ADDENDUM NO. ONE (1)
CITY OF SPARTA, GEORGIA
SPARTA SEWER SYSTEM REHABILITATION
CONTRACT 1 – PUMP STATION REPLACEMENTS
ISSUED OCTOBER 27, 2025

EMI PROJECT No. 23-021

This Addendum forms a part of the Contract Documents and Drawings, and modifies the original bidding documents dated October 2025.

FIGURE 3: SR22 IN THE WOODS

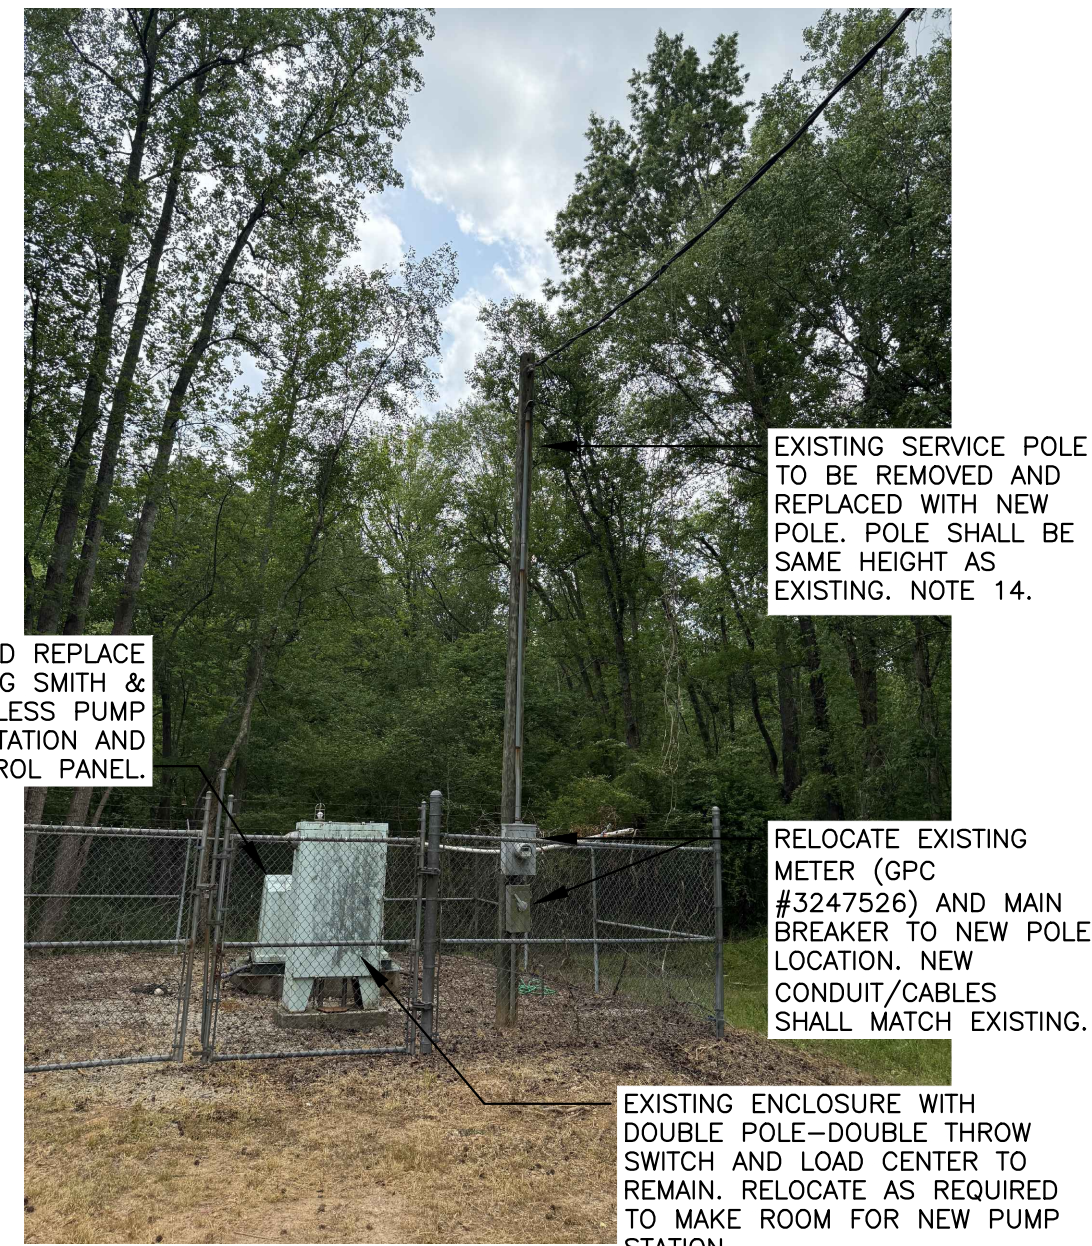
The following electrical plan sheets have been added to the project plans.

- **E1: Sparta Pump Stations Electrical Site Plans, Notes, and Details**

PS1

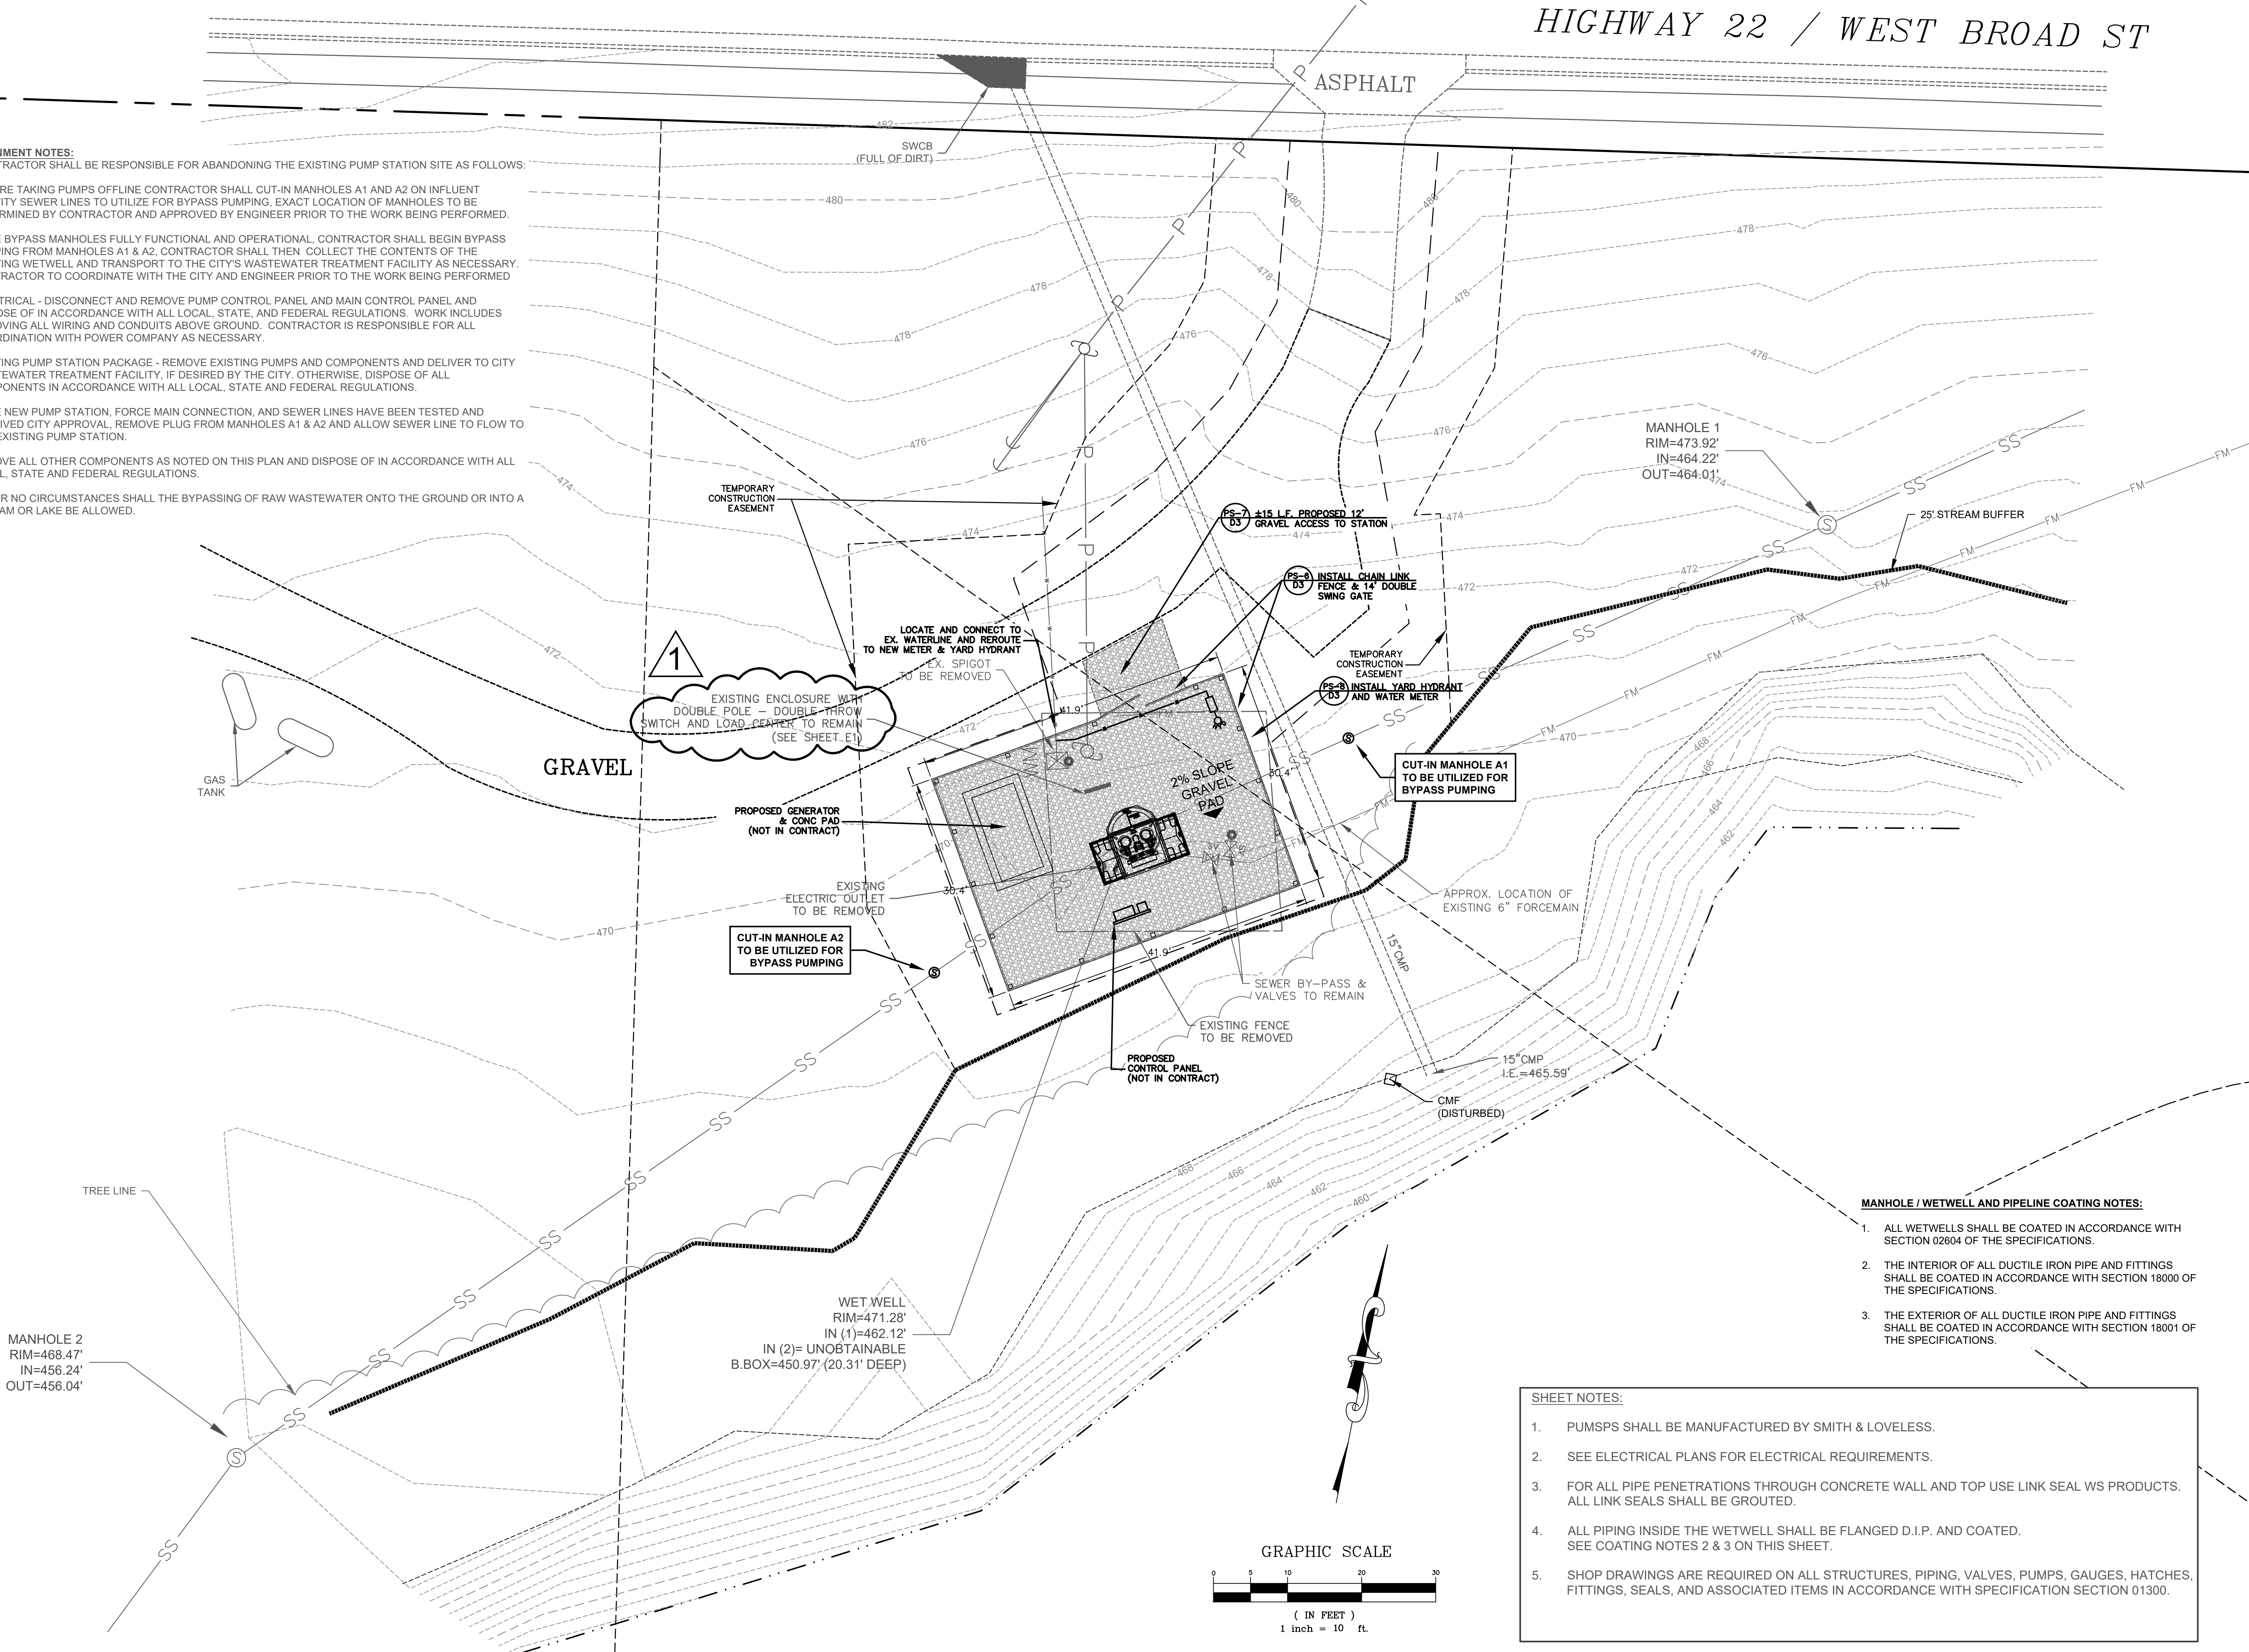
The following changes have been made to sheets PS1-PS3.1

- **Per the Electrical plan sheet callout on lift station sites that previously stated,**

EX. CONTROL PANEL TO BE REMOVED

has been updated to read,

**EXISTING ENCLOSURE WITH DOUBLE POLE - DOUBLE THROW SWITCH
AND LOAD CENTER TO REMAIN
(SEE SHEET E1)**
